ADDENDUM No. 1

South City Campus – Fire Alarm Upgrade

DFCM Project No. 08074670

Subject: Revisions to Fire Alarm Drawings for Addendum 1

SHEET FA-10:

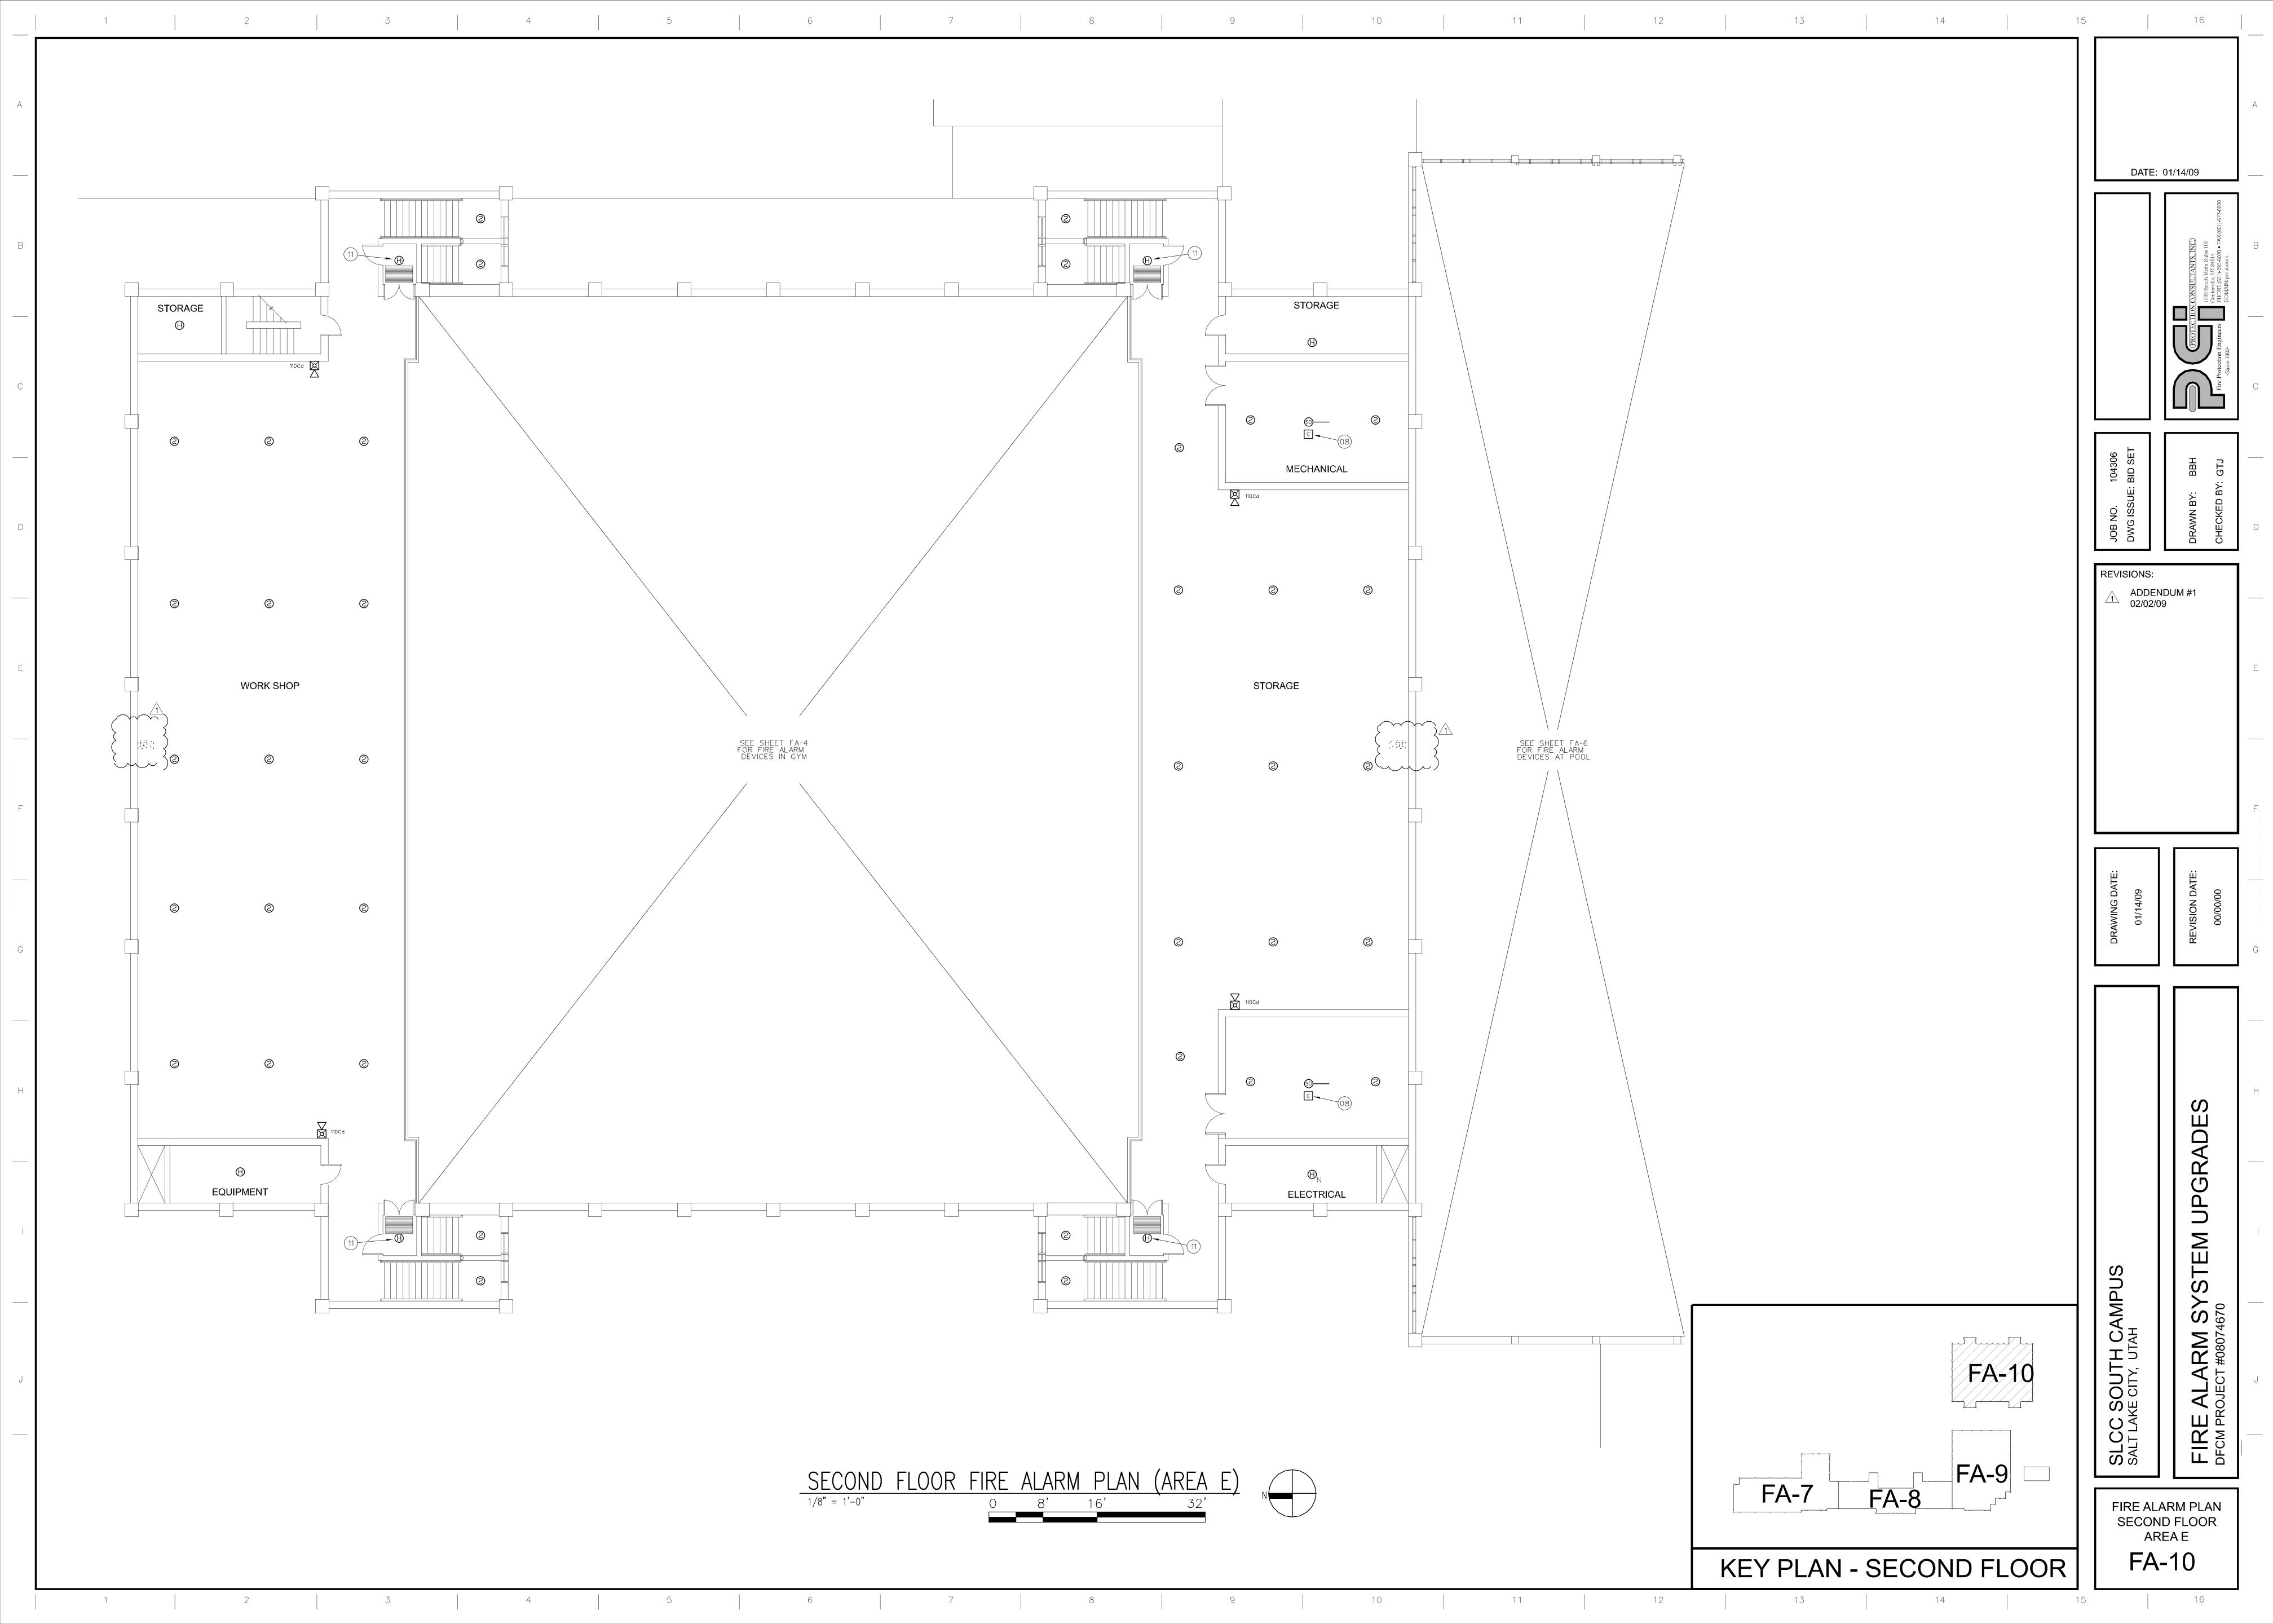
1. Indicated the location of two existing fire alarm notification appliances to be removed. I missed those devices in my survey and they were not shown on the bid set.

SHEETS FA-11 and FA-12:

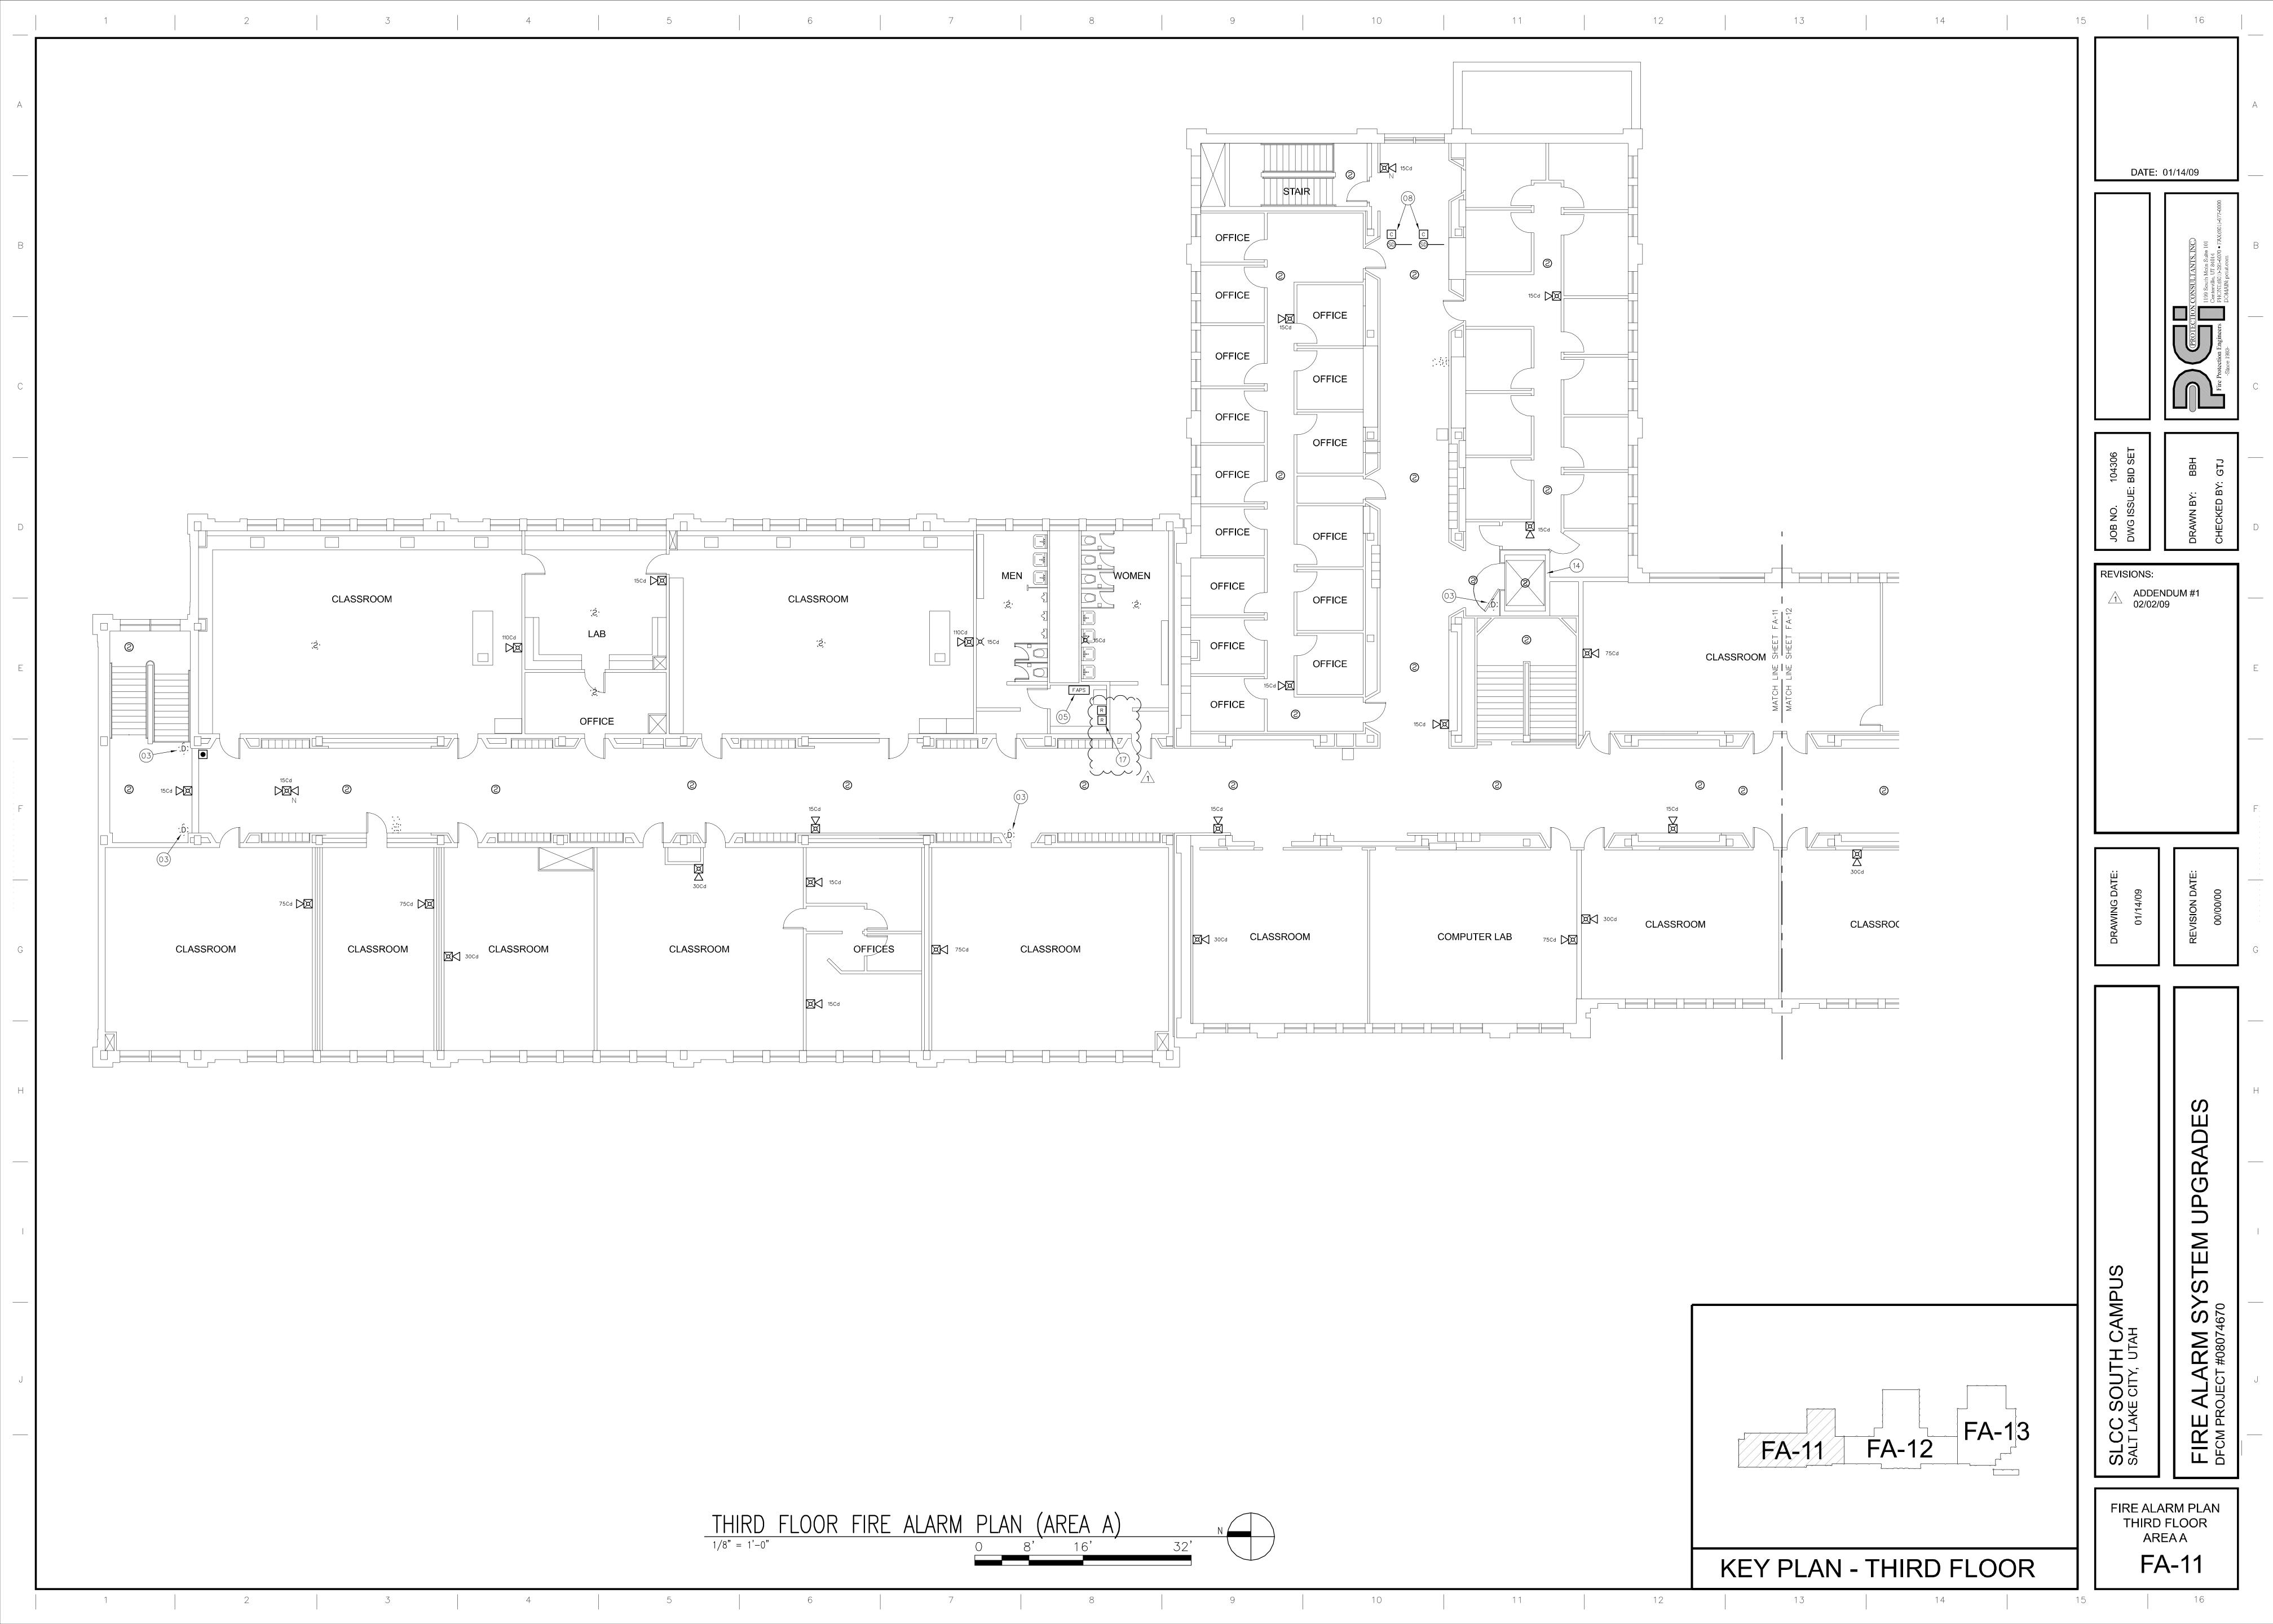
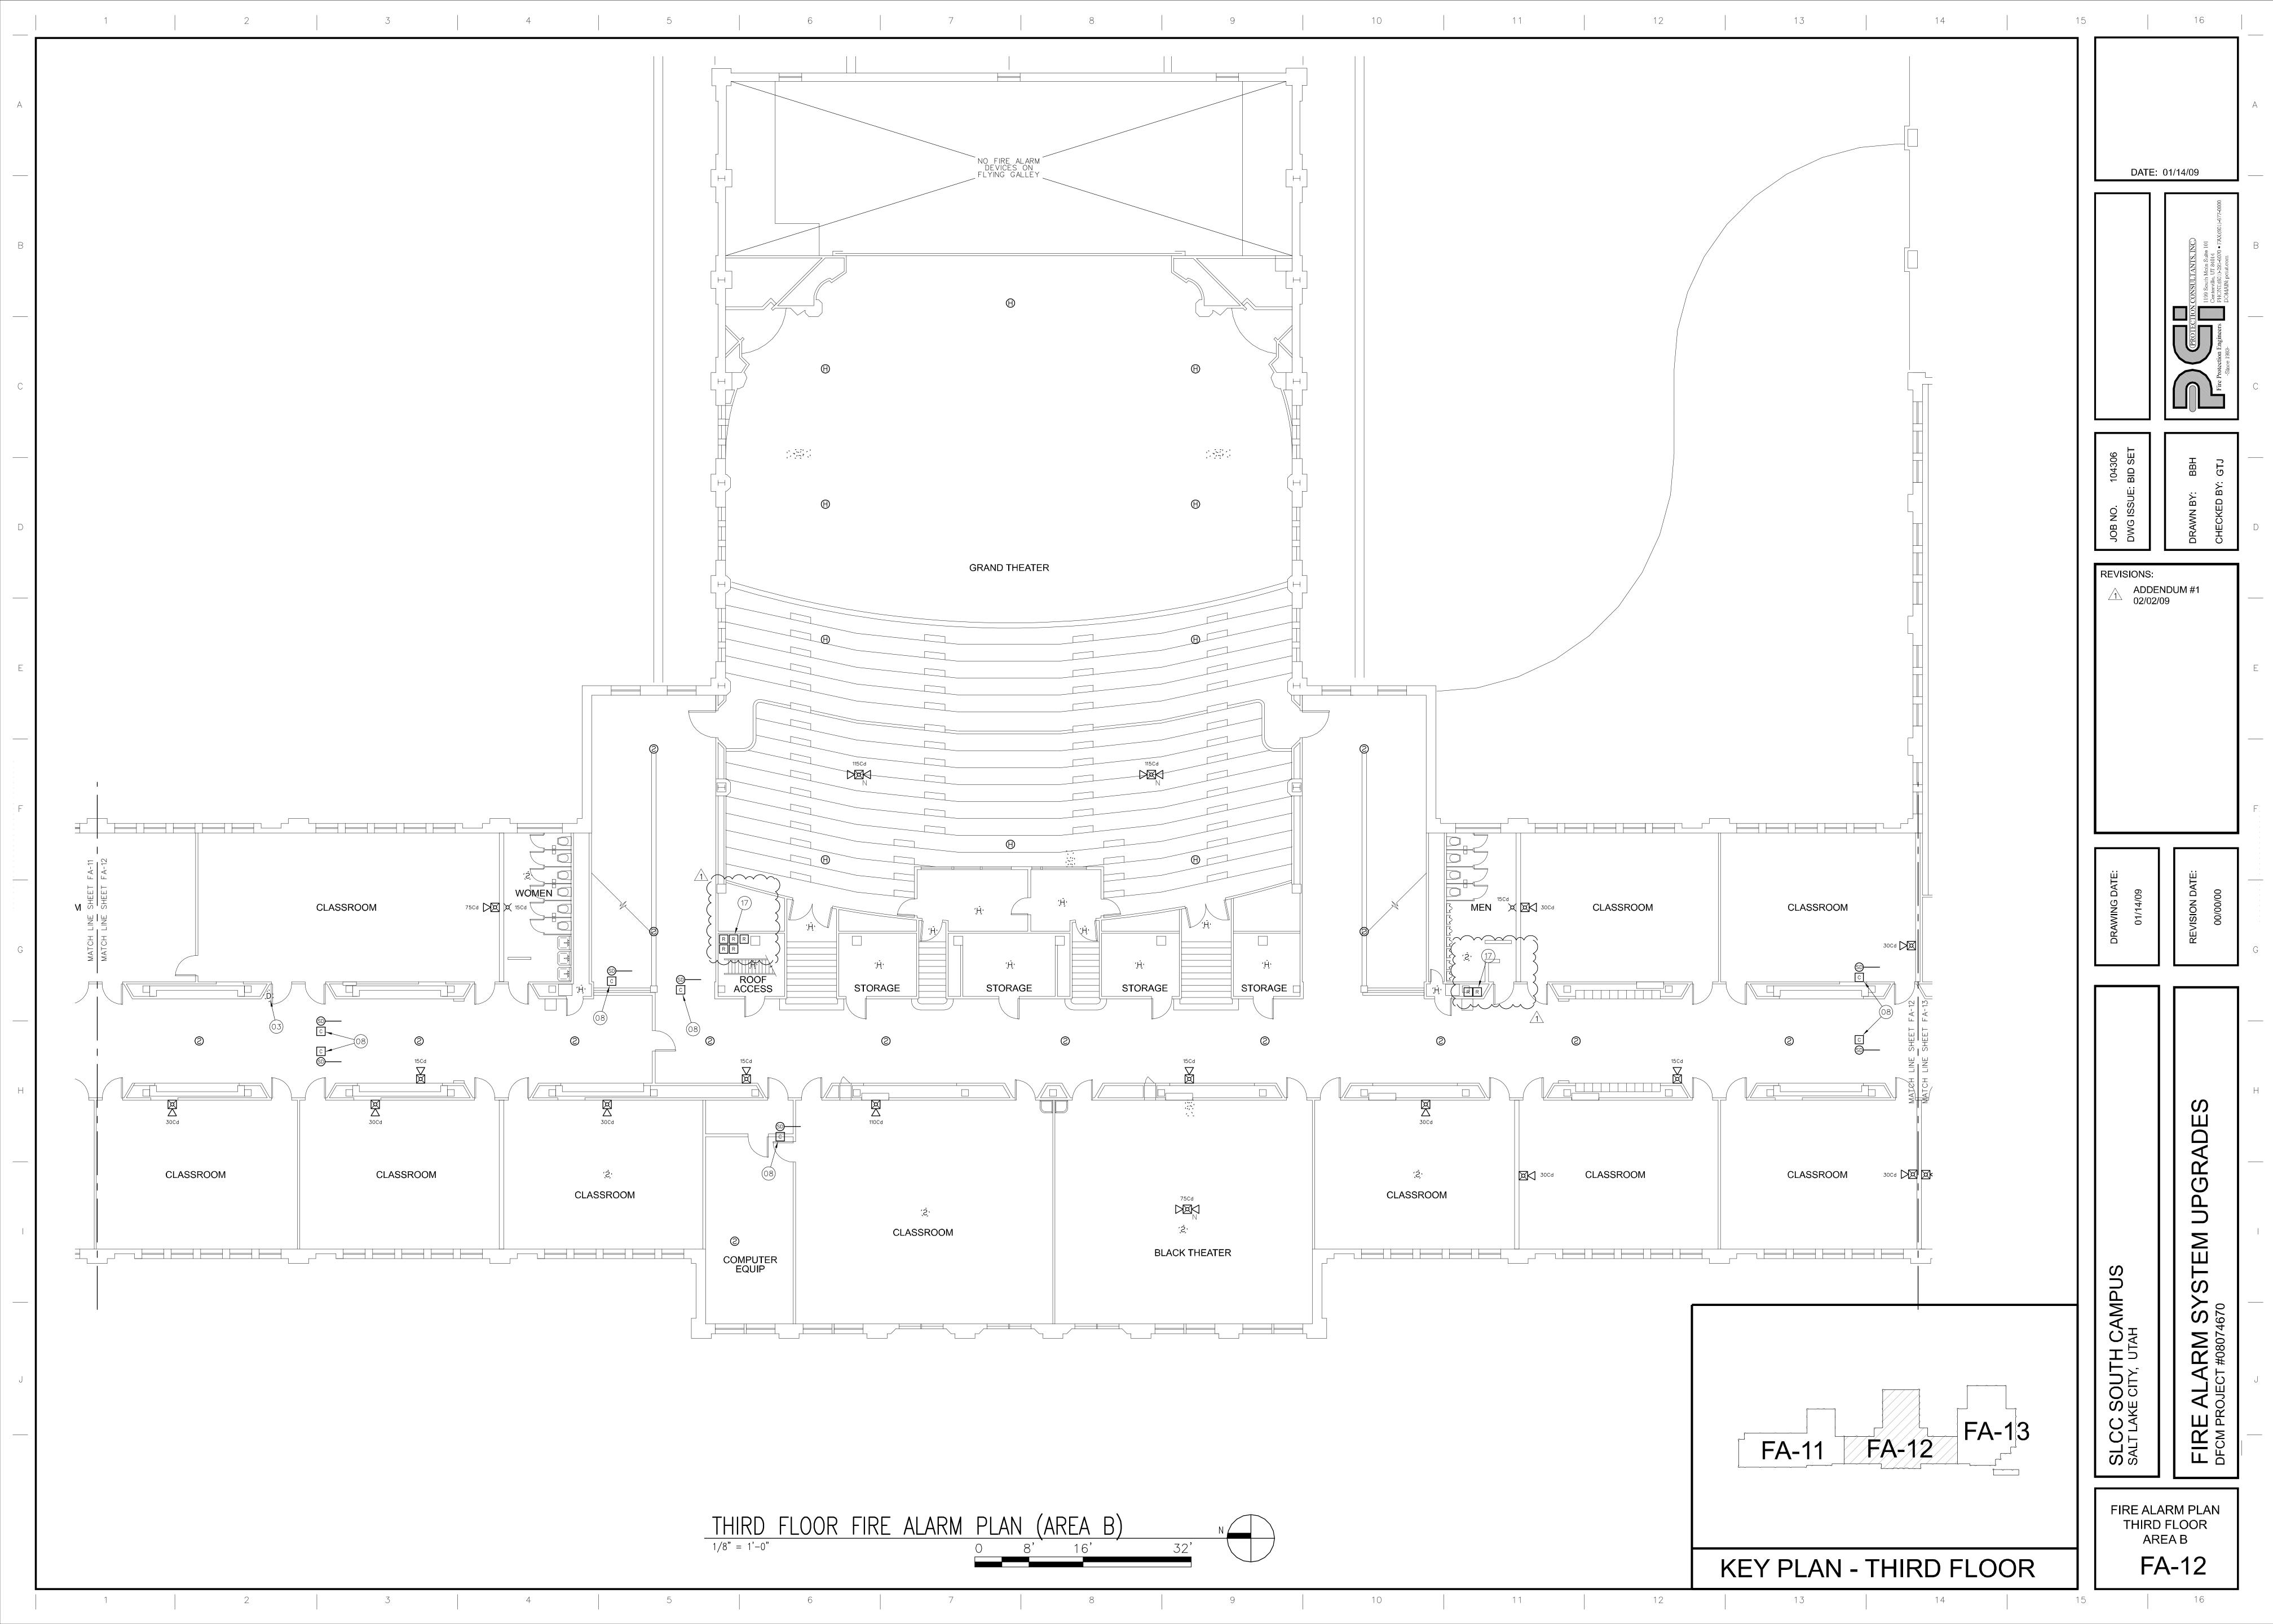
2. Added remote test switches for all duct smoke detectors located in difficult to access areas on the third floor.
